RE: 176 Loma Alta Avenue

I reviewed the drawings and evaluated the neighborhood context. My comments and recommendations on the design are as follows:

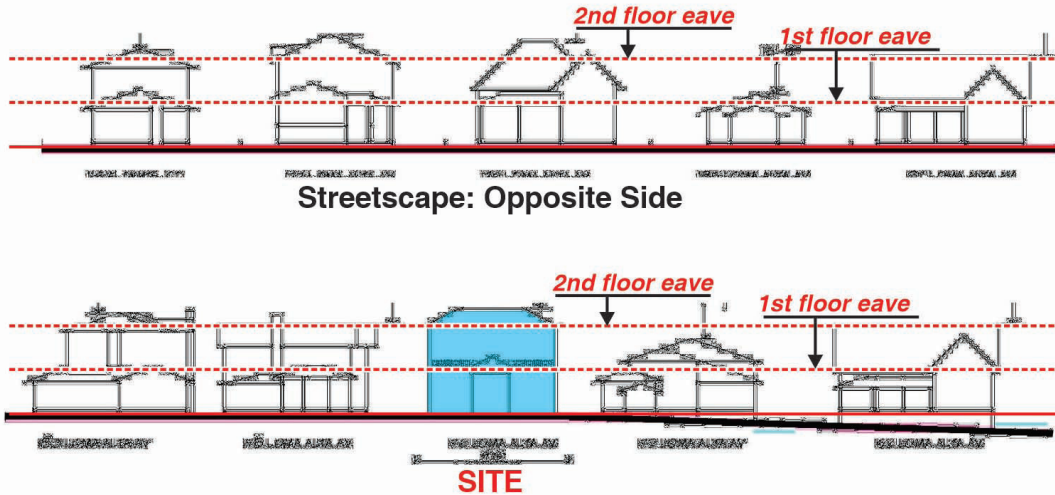
The proposed home is designed in an Italianate Victorian architectural style. While a bit unusual to see this style replicated today, it does not seem that it would be out of place in this neighborhood of eclectic architectural style homes. However, the two story front facade eave line is taller than the predominant building massing in its adjacent neighborhood. There are other second floor eaves of similar height nearby but they generally have gable ends facing the street rather than full width eaves. As mitigation the front facade would be broken by the proposed full width front porch.

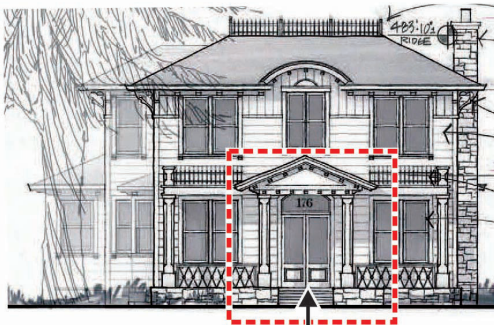
1. The gabled entry porch extension is much larger than is typical for this architectural style.

Porch entry extension too long and not characteristic with the style

Porch entry extension too long and not characteristic with the style

1. Eliminate the projecting entry gable in favor of a simple flat front porch eave line as is typical for this architectural style.
2. Add columns on the rear porch.
3. Eliminate the rear facade metal roofing in favor of using the same roofing as shown for the rest of the house.

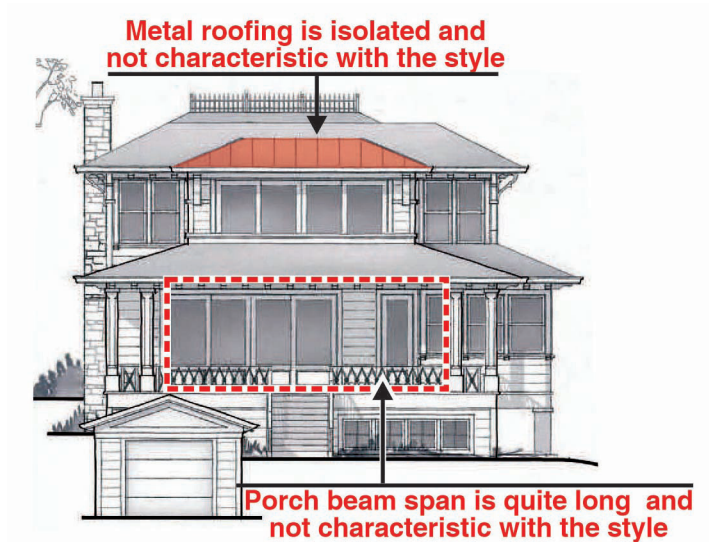
2. The rear porch beam span is quite long for this architectural style.
3. The rear elevation metal roof is isolated and would not be consistent with the proposed architectural style.

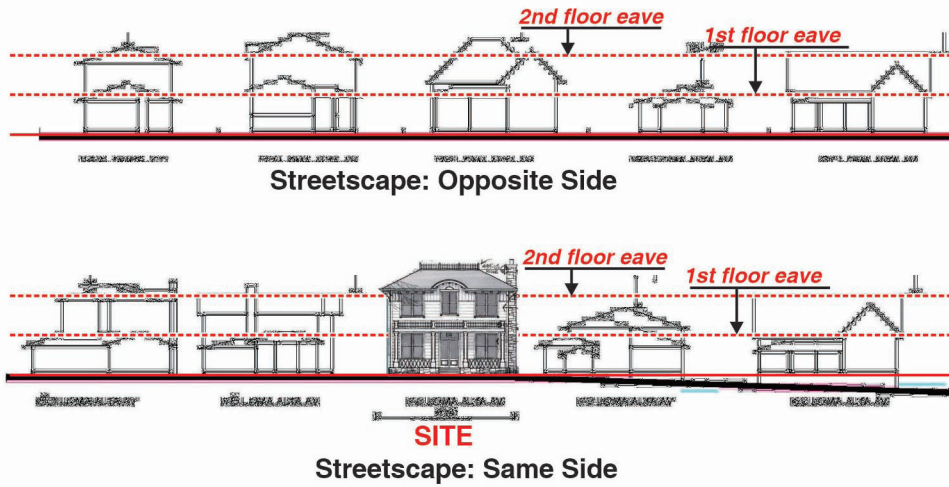
The streetscape comparison with the proposed change to the front facade is shown below.
